**Atchison Street
St Leonards, NSW**

Department Letter Response

Our ref: Shop Top Housing – 20-22 Atchison Street (SSD-87486461)

Subject: Department's Key Issues

Tower Typical Plan Level 30-38
1:200

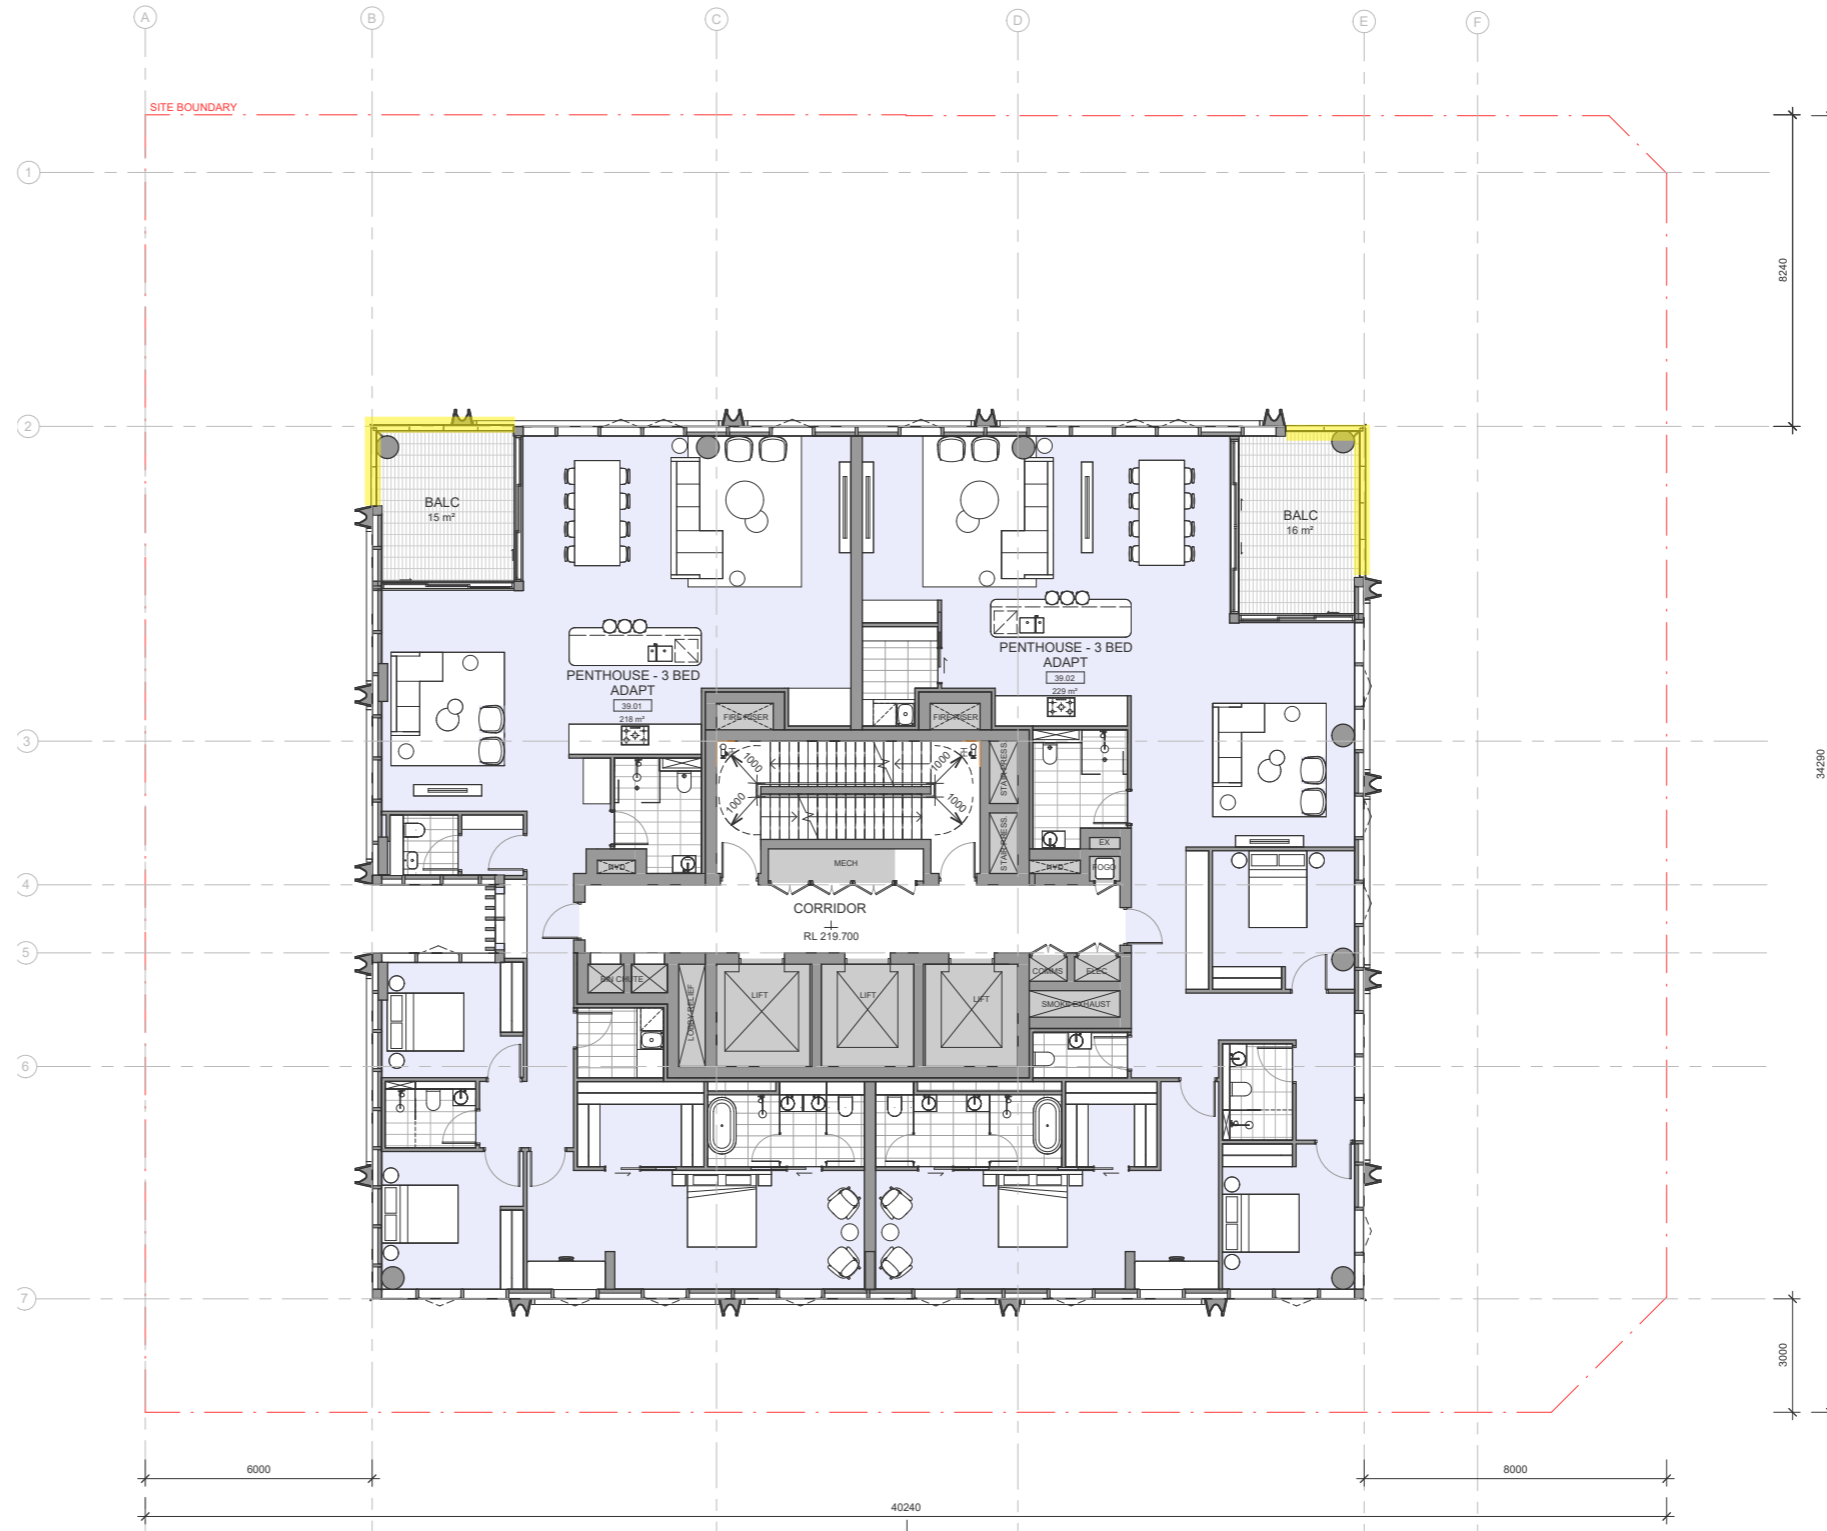
The fixed glass louvres included throughout the residential levels of the building allow for fully enclosed balconies and are therefore considered residential gross floor area (GFA) in accordance with the North Sydney Local Environmental Plan 2013. The balcony balustrades on Levels 2 and 3 also exceed 1.4 metres in height, potentially contributing to additional GFA. The total GFA of the development must be confirmed taking into account these matters. Any exceedance of the maximum floor space ratio (FSR) control for the site must be addressed in a clause 4.6 variation request.

- 1400mm Glass Balustrade with Fixed Louvres Above
- 1400mm Glass Balustrade
- 1400mm Glass Balustrade with Operable Louvres Above

Tower Balcony Louvres
1:20

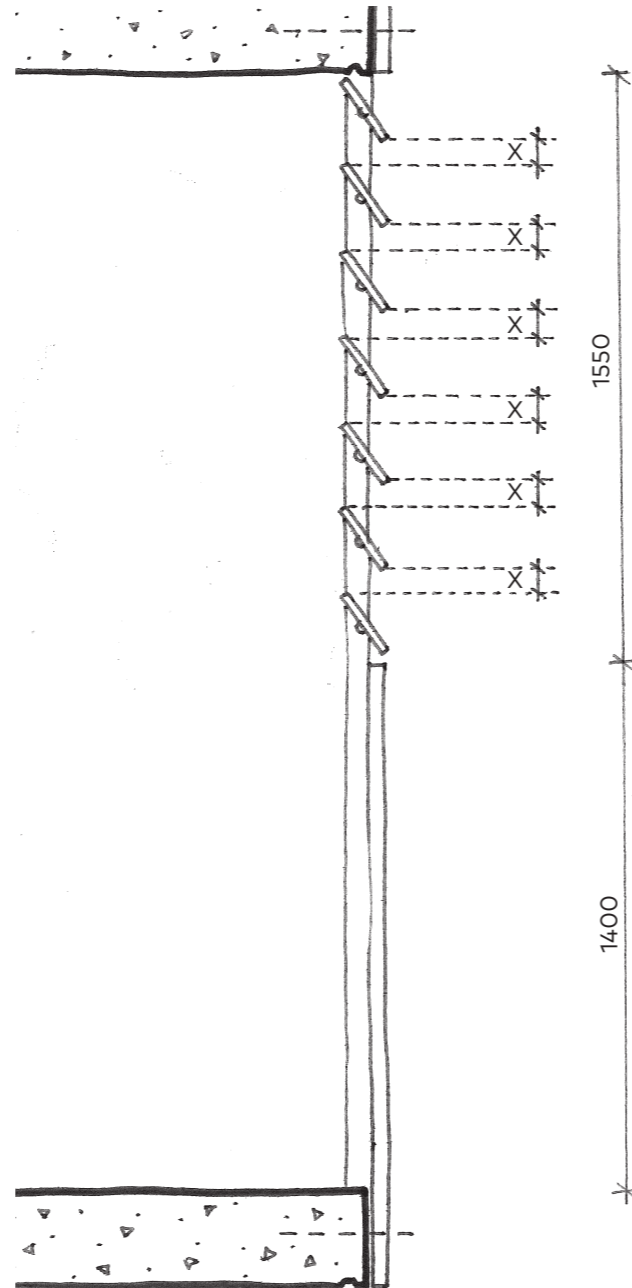
The fixed glass louvres included throughout the residential levels of the building allow for fully enclosed balconies and are therefore considered residential gross floor area (GFA) in accordance with the North Sydney Local Environmental Plan 2013. The balcony balustrades on Levels 2 and 3 also exceed 1.4 metres in height, potentially contributing to additional GFA. The total GFA of the development must be confirmed taking into account these matters. Any exceedance of the maximum floor space ratio (FSR) control for the site must be addressed in a clause 4.6 variation request.

Tower Louvres

Louvres fixed open as to not fully enclose/ weather protect external balconies, with 30% openings.

NOTE: Wind Report findings were tested with the assumption that louvres were retained on all balconies.

Level 6-14 GFA Plan
1:500

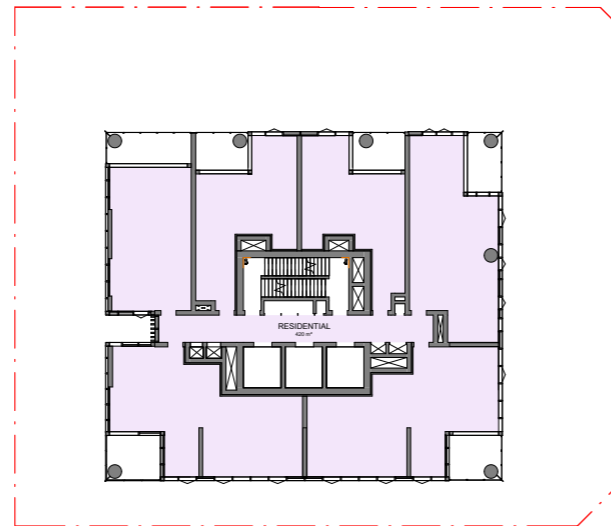
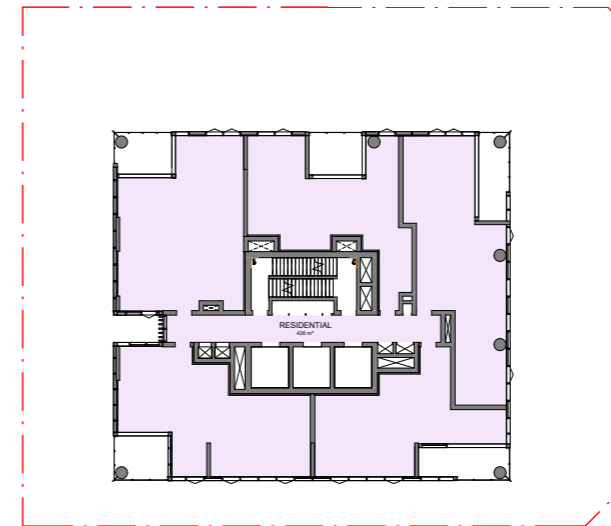
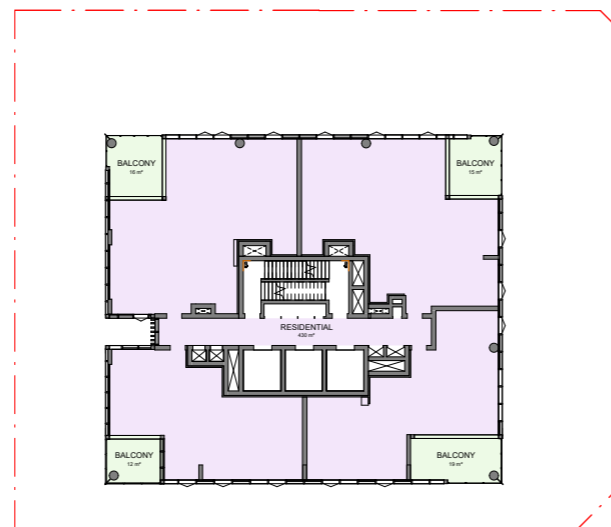
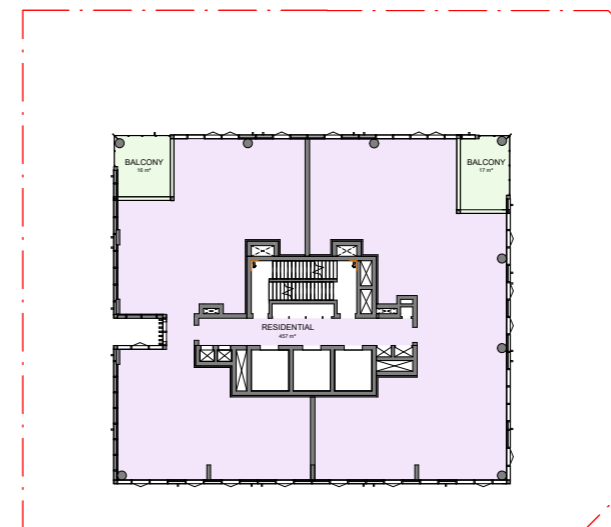
The fixed glass louvres included throughout the residential levels of the building allow for fully enclosed balconies and are therefore considered residential gross floor area (GFA) in accordance with the North Sydney Local Environmental Plan 2013. The balcony balustrades on Levels 2 and 3 also exceed 1.4 metres in height, potentially contributing to additional GFA. The total GFA of the development must be confirmed taking into account these matters. Any exceedance of the maximum floor space ratio (FSR) control for the site must be addressed in a clause 4.6 variation request.

AREA SCHEDULE - TOTAL GFA	
AREA TYPE	AREA
BALCONY	602 m ²
COMMERCIAL	1938 m ²
RESIDENTIAL	16450 m ²
TOTAL	18990 m²

PERMISSIBLE GFA: 18,961m²
NON-COMPLIANCE: 29m²

NOTE: There are no proposed GFA changes to the podium levels.

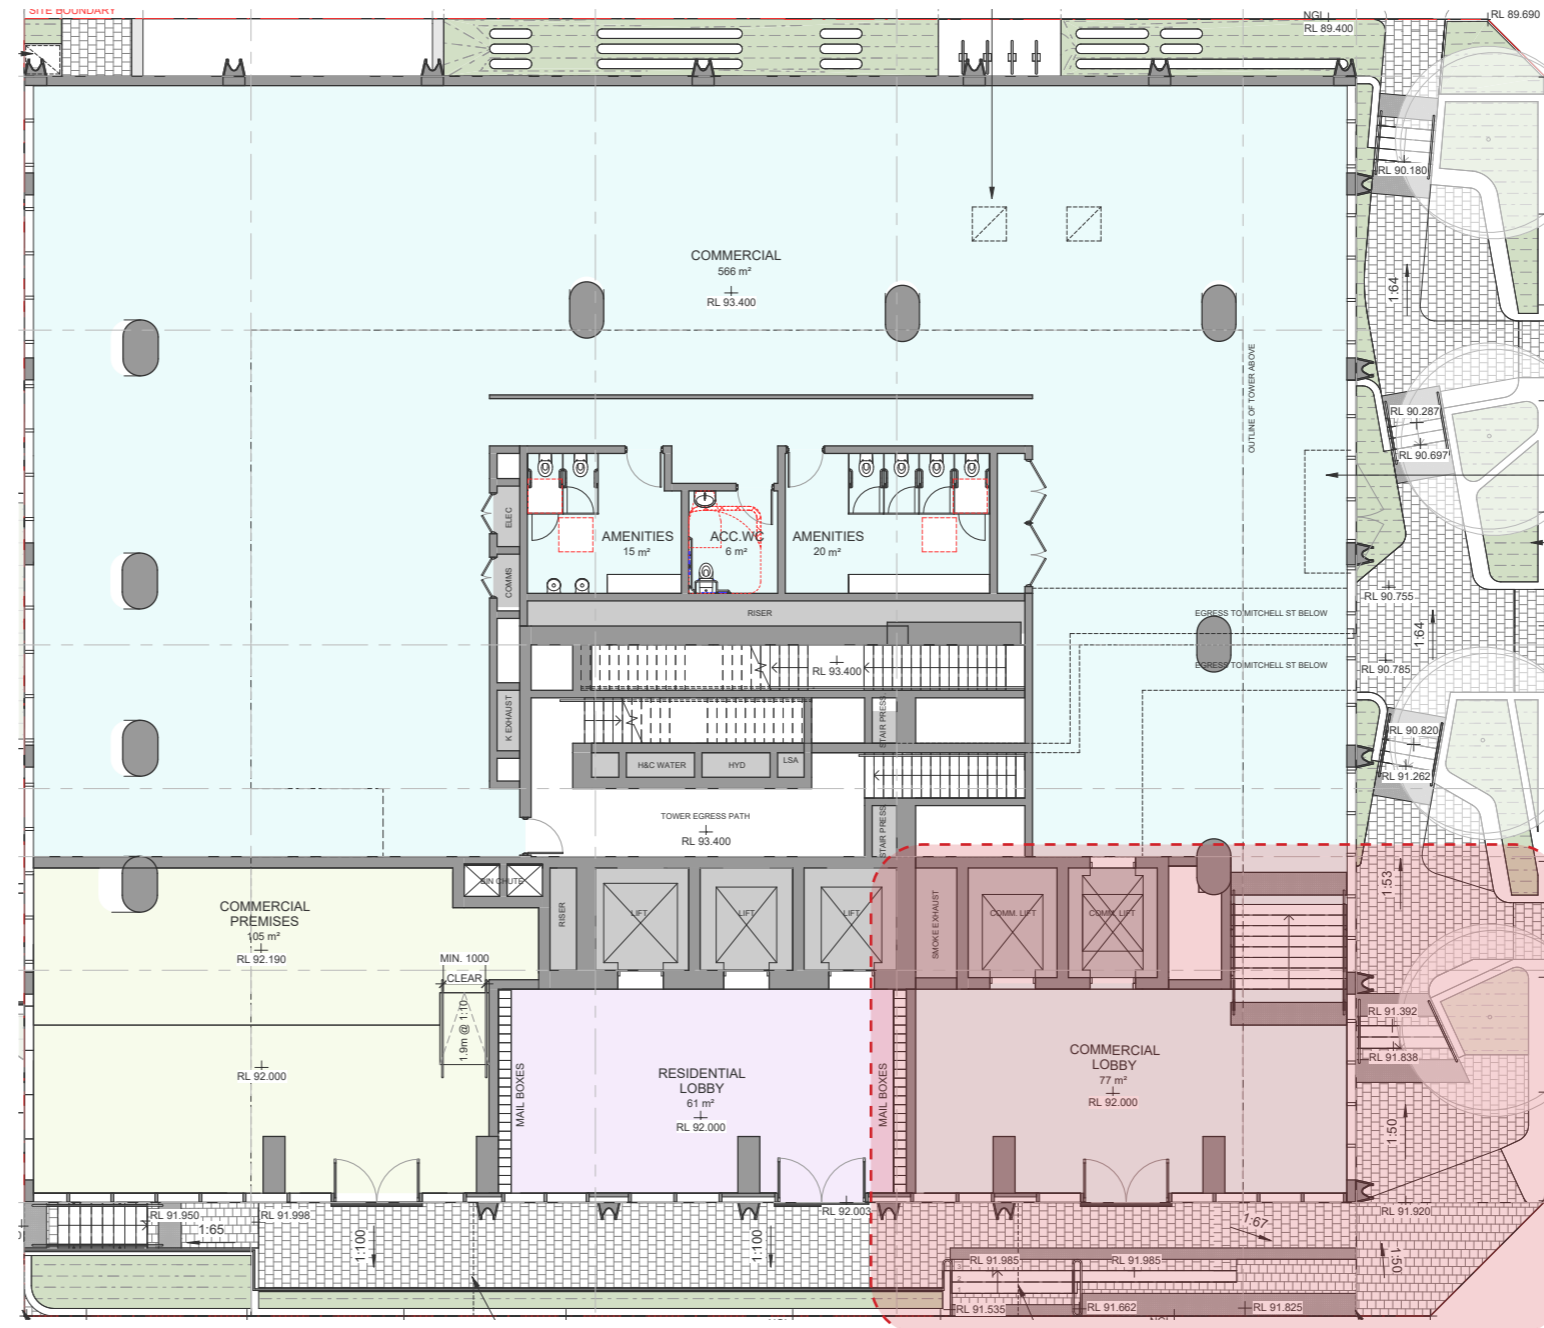
- a. **Consider alternative design options or removal of the fixed glass louvres to reduce the bulk and scale of the development and ensure compliance with the FSR control.**
- b. Street activation along the Atchison Street and Mitchell Street frontages should be further explored to accord with the Crows Nest TOD Precinct Design Guide.
- c. Consider improved street activation and/ or landscaping of the through-site link along the western boundary of the site to screen the inactive facade.

As per design changes shown in previous section, and the below updated SSDA Architectural Sheets:

A-DA-3100-BUILDING ELEVATIONS - NORTH & EAST
A-DA-3001-BUILDING ELEVATIONS - SOUTH & WEST
A-DA-9100-DEVELOPMENT CALCULATIONS GFA - SHEET 1
A-DA-9101-DEVELOPMENT CALCULATIONS GFA - SHEET 2

Ground Floor Cafe Activation Plan
1:100

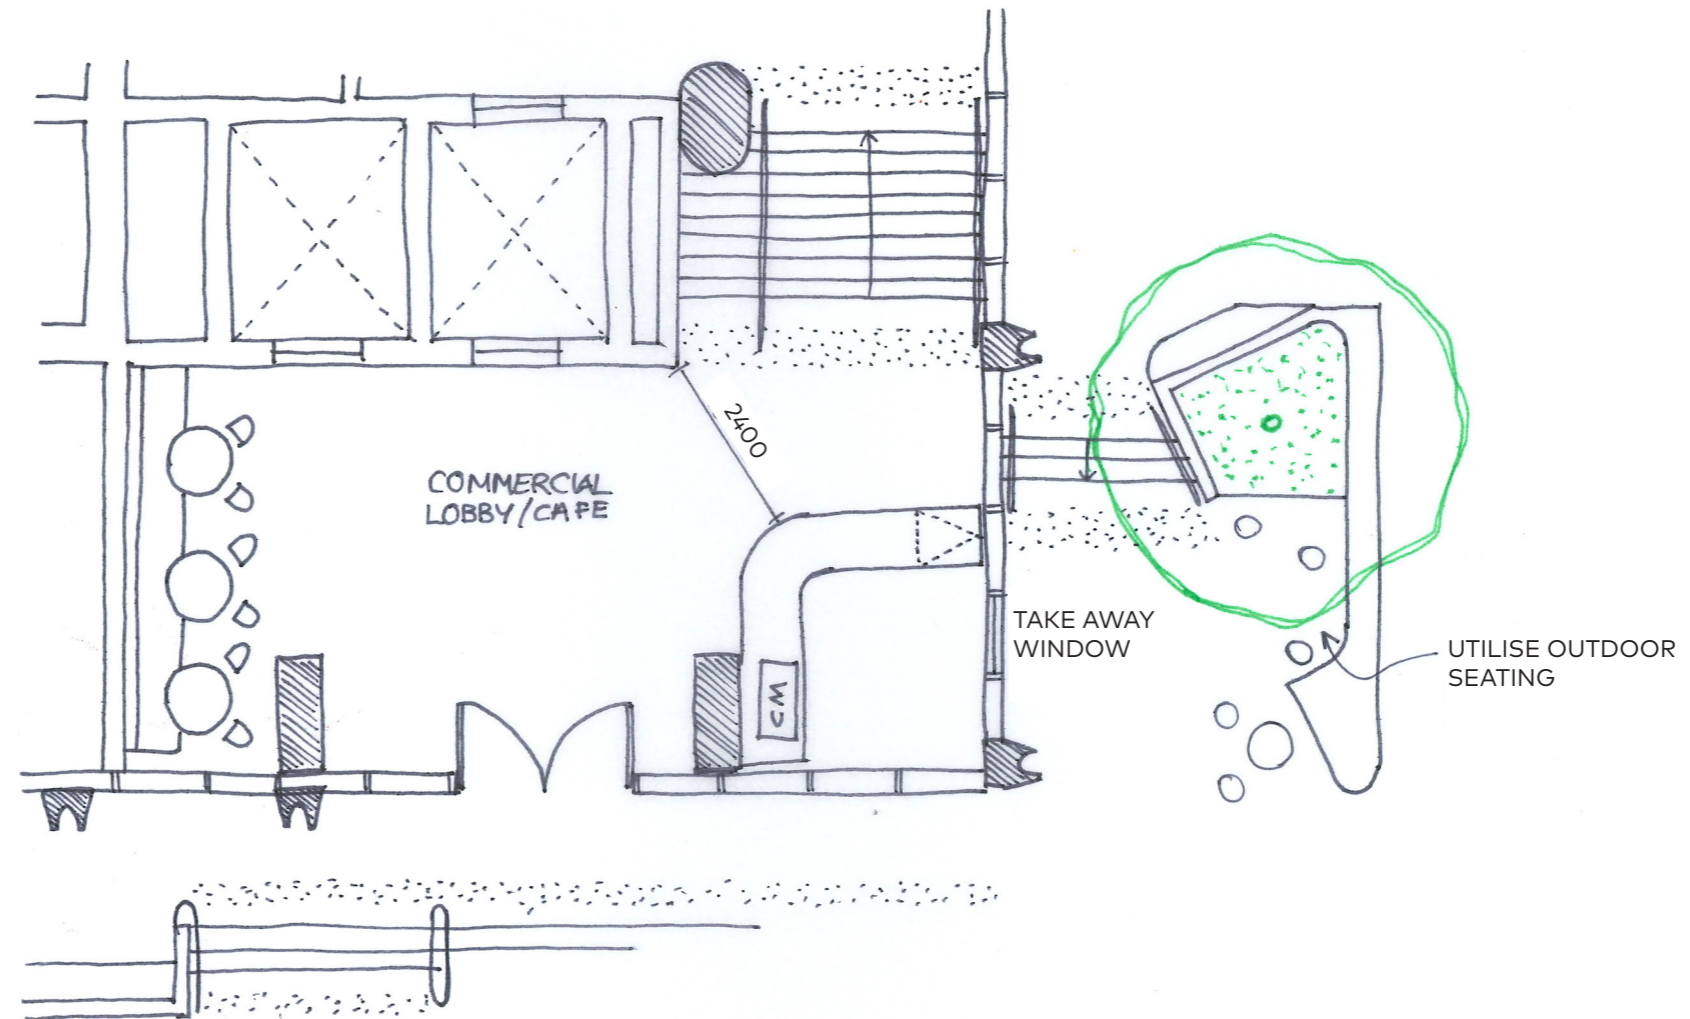
- a. Consider alternative design options or removal of the fixed glass louvres to reduce the bulk and scale of the development and ensure compliance with the FSR control.
- b. Street activation along the Atchison Street and Mitchell Street frontages should be further explored to accord with the Crows Nest TOD Precinct Design Guide.**
- c. Consider improved street activation and/ or landscaping of the through-site link along the western boundary of the site to screen the inactive facade.

- Cafe can operate within the Commercial Lobby, servicing staff internally, and the public through a take away window opening onto the Mitchell Street green link.
- Cafe customers can utilise and activate the landscaped seating of the Mitchell Street green link.
